Rezoning Transportation Analysis

Petition Number: #2022-125

Date	Description
12-29-22	First Review (TM)
1-27-23	Second Review (DR)

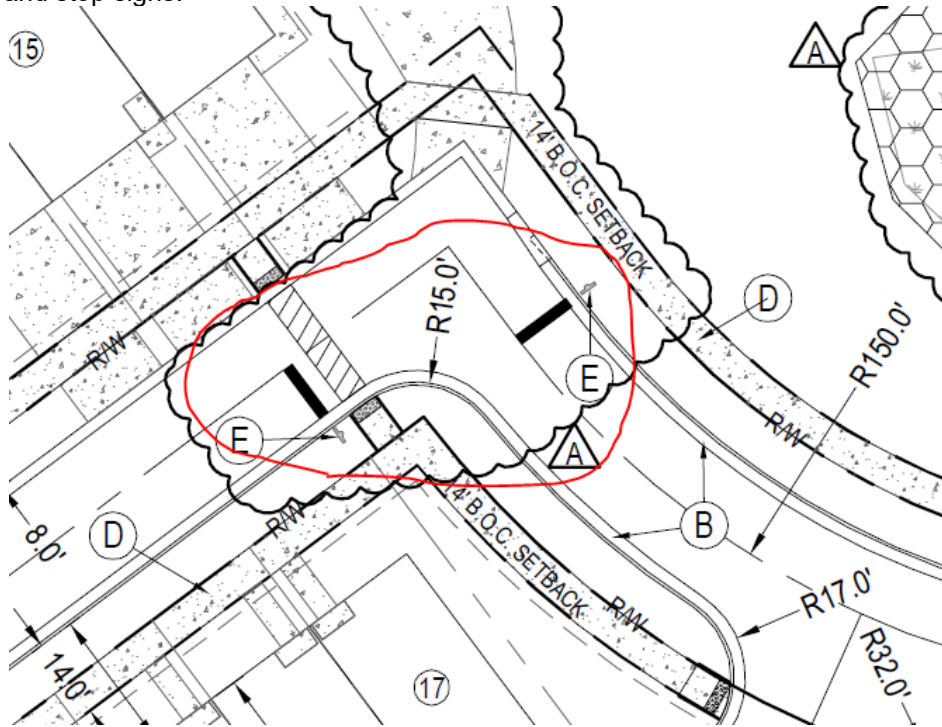
6. Revise site plan and conditional note(s) to meet CDOT standards for public roadway geometry. Label each roadway as public or private.

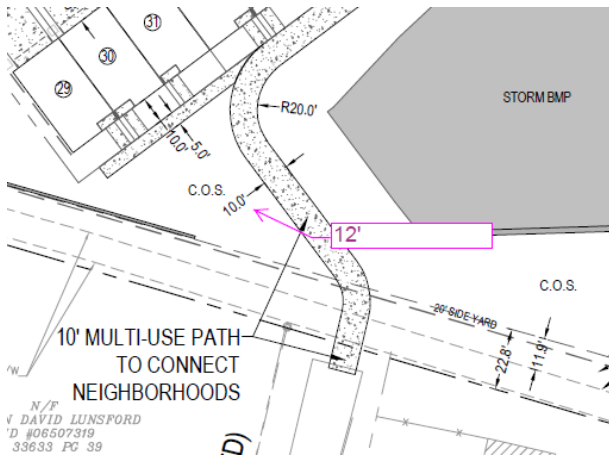
Clarifying Comment 01-27-23: CDOT will not accept current design. Revise roadway to remove 90 degree turn and satisfy CDOT standards for public roadway geometry. Remove crosswalk, stop bars, and stop signs.
